REF: SUP25-0036  
DATE: January 15, 2026

Request - Special Use Permit for Gasoline and Fuel Sales  
Location - 5305 and 5321 Monroe and 4700 Nantucket (2 parcels)  
Applicant / Developer - Skilken Gold Development, LLC  
4270 Morse Rd  
Columbus, OH 43230  
Owner - Grimon Properties Limited  
4442 Alexis Road  
Toledo, Ohio 43623  
Tenant - Sheetz, Inc.  
5700 Sixth Avenue  
Altoona, PA 16602  
Engineer - Civil & Environmental Consultants, Inc.  
8800 Lyra Drive Suite 300  
Columbus, OH 43240

SPECIAL USE PERMIT  
TOLEDO CITY PLAN COMMISSION  
REF: SUP25-0036  
DATE: January 15, 2026  
TIME: 2:00 P.M.

# SITE PLAN

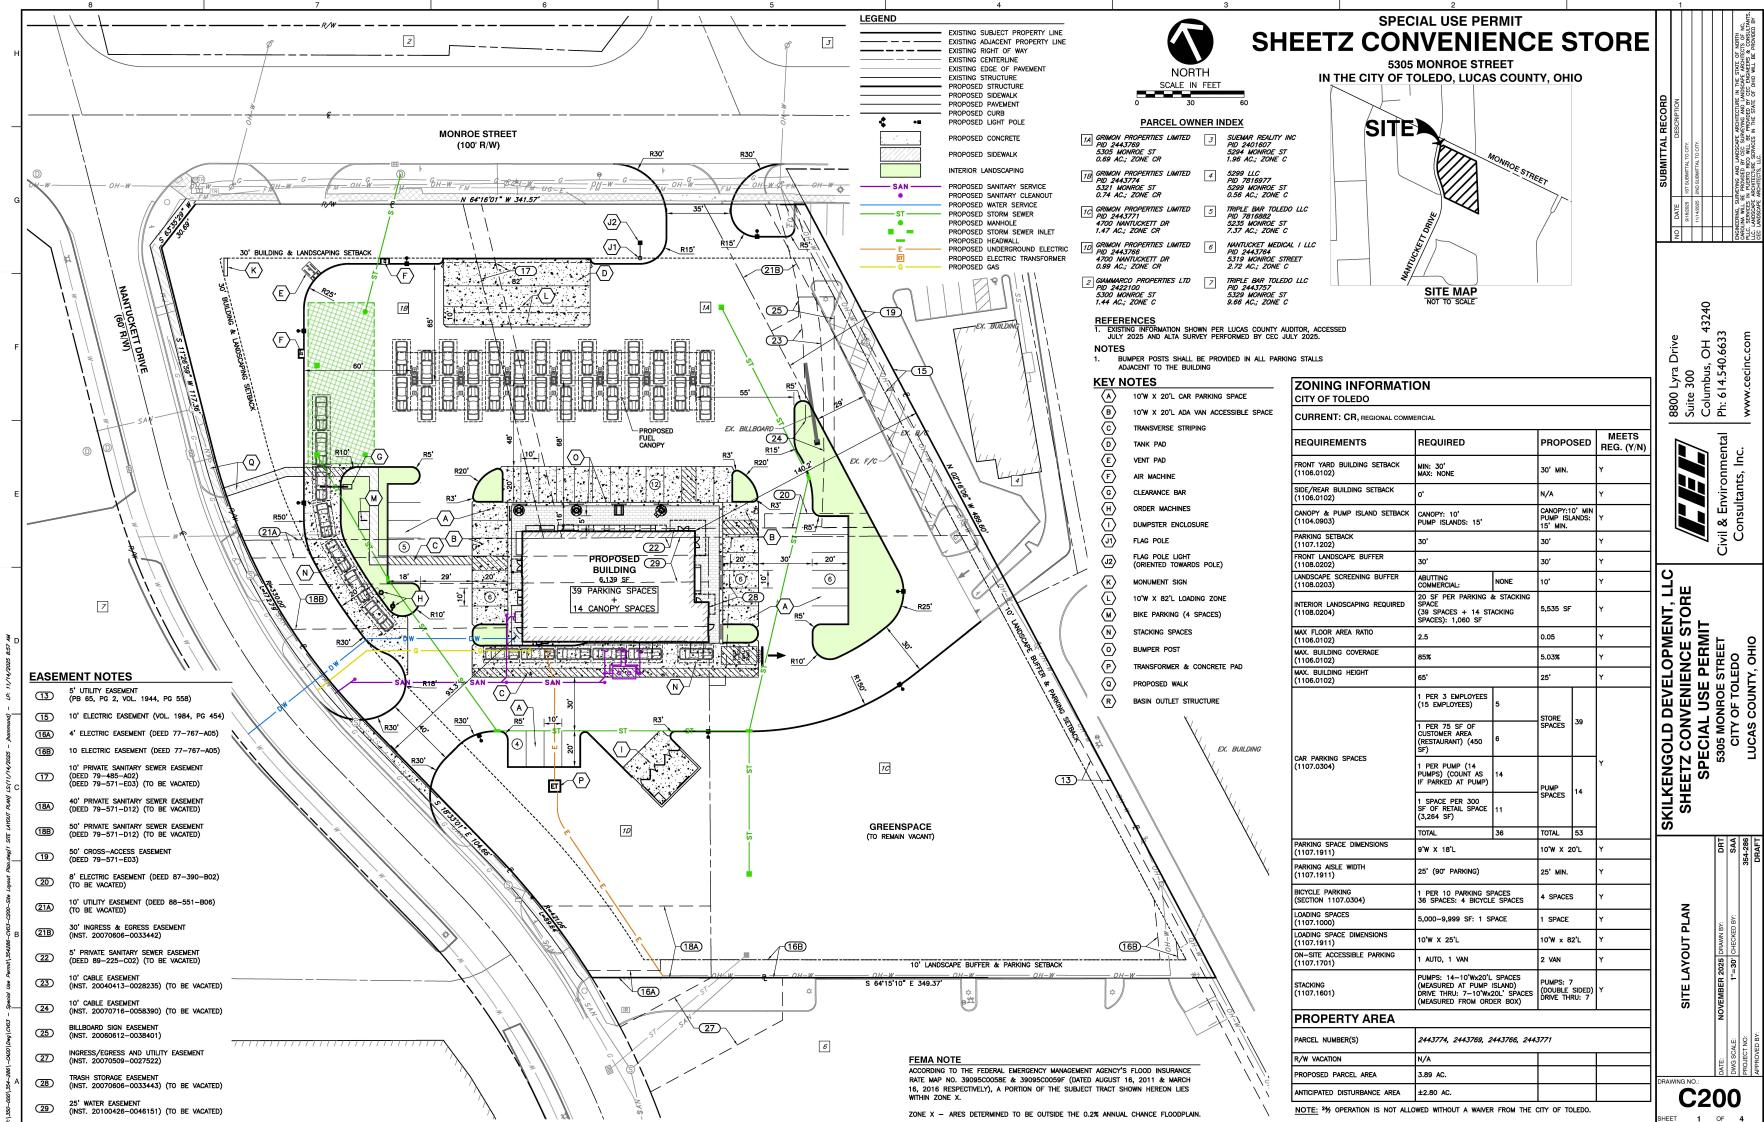
The site will have two (2) access drives, one (1) from Monroe Street and one (1) from Nantucket Drive. The primary façade of the building will face Monroe Street and the majority of the parking will be located along the north, east and west building facades. A drive-thru is located along the western and southern portions of the site, with vehicle stacking beginning at the northwest portion. There is an existing sidewalk along Monroe Street, and the applicant is proposing to install a sidewalk along Nantucket Drive.

Bicycle parking is required per TMC§1107.0304 Schedule A at a rate of one (1) bicycle parking slot per 10 parking spaces. Based on the forty (40) marked parking spaces provided, four (4) bicycle slots are required. The site plan illustrates that four (4) bicycle slots will be provided along Nantucket Drive and connected to the proposed Nantucket Drive sidewalk. The site plan meets this requirement.

Accessible off-street parking is required per TMC§1107.1700 at a rate of one (1) car accessible parking space, with at least a five-foot (5') wide aisle abutting the designated space, and one (1) van accessible parking space, with at least an eight-foot (8') wide aisle abutting the designated parking space, are required when there are twenty-six (26) to fifty (50) total parking spaces. The proposed site plan meets this requirement as two (2) van accessible parking spaces are provided.

31. Should charging stations for electric vehicles be provided, they shall meet the requirements of TMC§1105.1300.
32. Parking is allowed up to the amount stated in TMC§1107. Applicant is permitted a maximum of forty-two (42) spaces and have provided forty (40) marked spaces. **Acceptable as depicted.**

33. Bicycle parking slots shall be provided per TMC§1107.0304 Schedule A for the proposed gas station and restaurant uses. Four (4) bicycle parking slots are required. The site plan depicts four (4) bicycle parking slots and meet the requirement. **Acceptable as depicted.**

34. Accessible off-street parking spaces shall be provided per TMC§1107.1700. A minimum of one (1) car accessible space and one (1) van accessible space is required for the site. The site plan depicts two (2) van accessible spaces. **Acceptable as depicted.**

35. Sidewalks shall be provided along all public streets in commercial districts per TMC§1107.1303. **Acceptable as depicted.**
36. Off-street parking and loading spaces, parking lots, maneuvering areas, aisles and driveways must be surfaced with concrete, bituminous asphalt, or other dust-free material other than gravel or loose fill, and be graded to drain all surface water towards the interior of the parking lot.

# LANDSCAPE PLAN

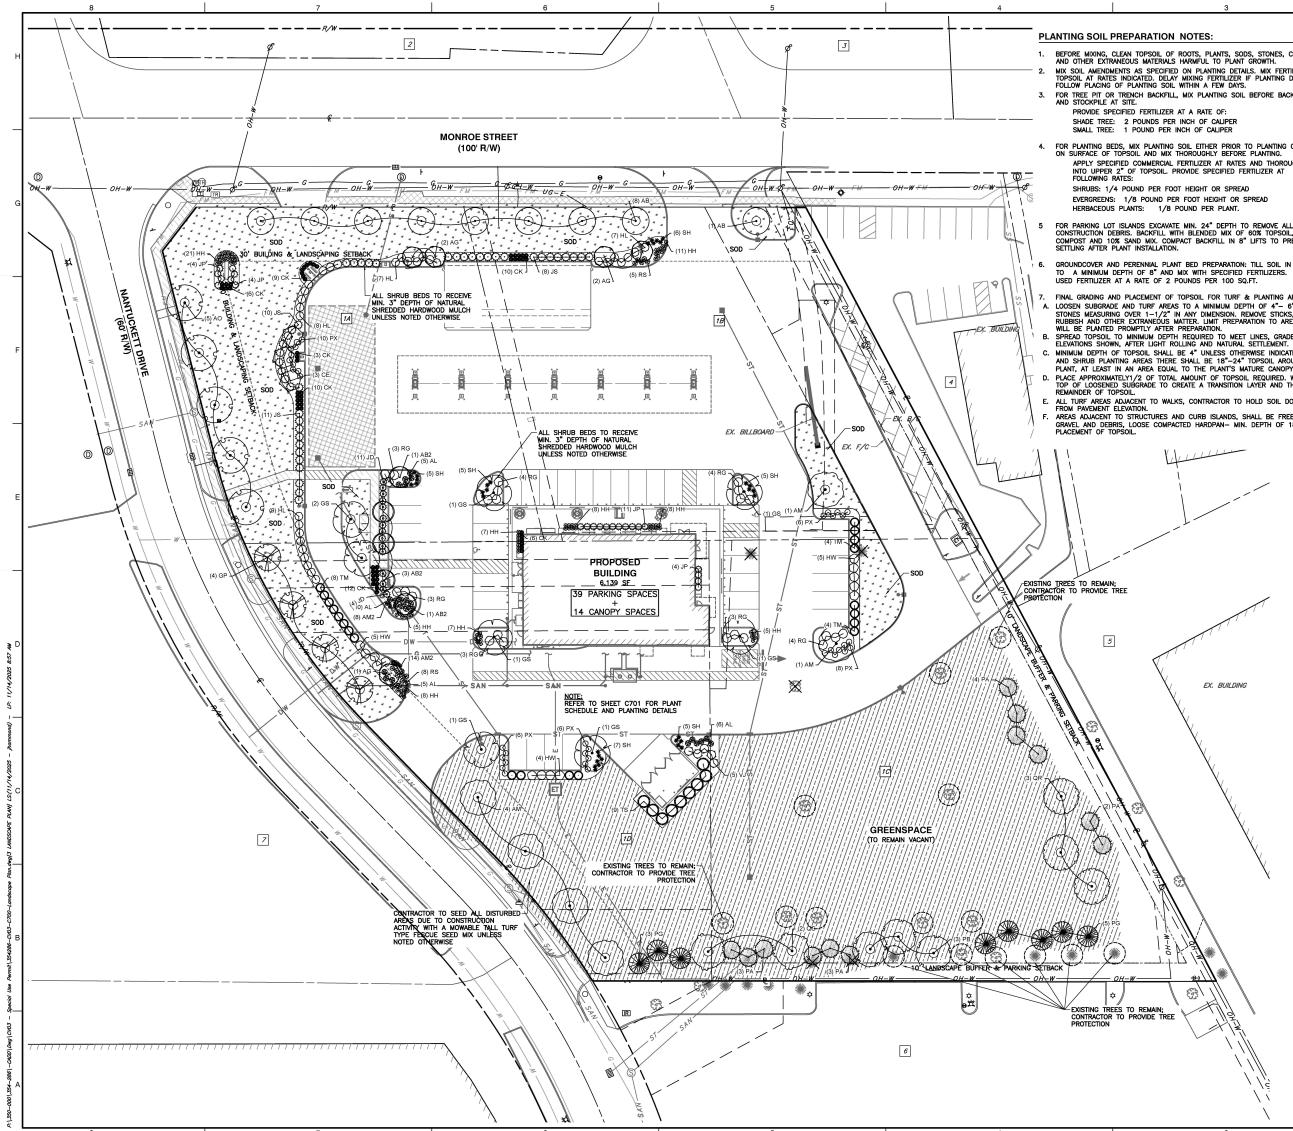
A minimum 15-foot (15') wide frontage greenbelt per TMC§1108.0202, is required along both Monroe Street and Nantucket Drive. This greenbelt must contain at least one (1) tree for every thirty feet (30') of frontage. A total of twenty-two (22) trees are required for the site. The landscape plan depicts a total of twenty-one (21) trees with eight (8) along Monroe Street and thirteen (13) along Nantucket Drive. Additionally, a shrub row is depicted along the perimeter of the parking lot to shield headlights. One (1) additional tree is required in the frontage greenbelt as a condition of approval.

Parking lot perimeter landscaping is required per TMC§1108.0204(B)(9) and must be installed along any parking lot area adjacent to a street, place, or driveway, or is visible from an immediately adjacent property. The trees in the frontage greenbelt are allowed to fulfill this requirement if the parking lot is along a right-of-way per TMC§1108.0204(D)(1). A shrub row is depicted surrounding the parking lot as well, and the proposed perimeter parking lot landscaping is acceptable as depicted.

Interior landscaping for parking lots is required per TMC§1108.0204 at a rate of two (2) canopy trees and six (6) shrubs for each ten (10) parking spaces within the parking lot. With forty (40) designated parking spaces proposed, eight (8) canopy trees and twenty-four (24) shrubs are required. The submitted landscape plan complies with this requirement as it depicts ten (10) trees and shrubs in excess of this amount. The interior parking lot landscaping is acceptable as depicted.

- a. A fifteen-foot (15') frontage greenbelt along Monroe Street and Nantucket Drive is required per TMC§1108.0202. **Not acceptable as depicted. One (1) additional tree is required in the frontage greenbelt.**

- b. Dumpster screening is required per TMC§1108.0203(G). **Acceptable as depicted.**
  - c. Parking lot perimeter landscaping is required per TMC§1108.0204(B)(9) and must be installed along any parking lot area adjacent to a street, place, or driveway, or is visible from an immediately adjacent property. **Acceptable as depicted.**

- d. Interior parking lot landscaping is required per TMC§1108.0204. Eight (8) canopy trees and twenty-three (24) shrubs are to be provided. Trees and shrubs in excess of this amount are provided. **Acceptable as depicted.**

- e. Interior site landscaping is required per TMC§1108.0205. Seven (7) trees, landscaping at major building entrances, and foundation plantings are required. **Acceptable as depicted.**

# REAR & RIGHT ELEVATION

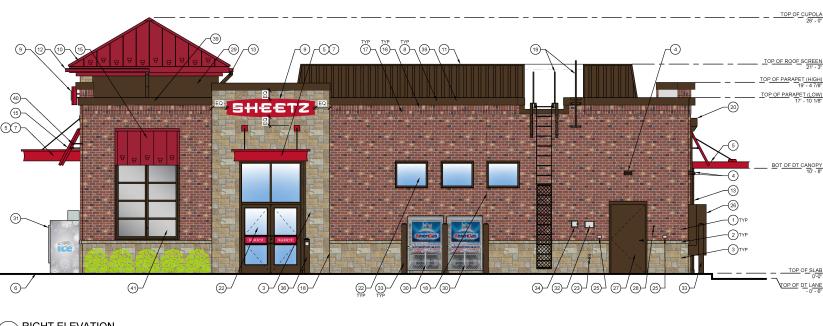
The elevations of the proposed building are subject to building material and color standards per TMC§1109.0500. Building material standards apply to all facades that are visible from the right-of-way. Building color standards apply to all exterior elevations regardless of right-of-way visibility. At least eighty percent (80%) of each elevation shall be comprised of predominant building materials and colors; and up to twenty percent (20%) of each elevation may be comprised of accent building materials and colors. The proposed building consists of mainly brick and cast stone masonry veneer. These are considered predominant building materials. Therefore, the proposed building meets this requirement.

40. All building elevations shall meet building material and color standards per TMC§1109.0500 since they are visible from a right-of-way. **Acceptable as depicted.**
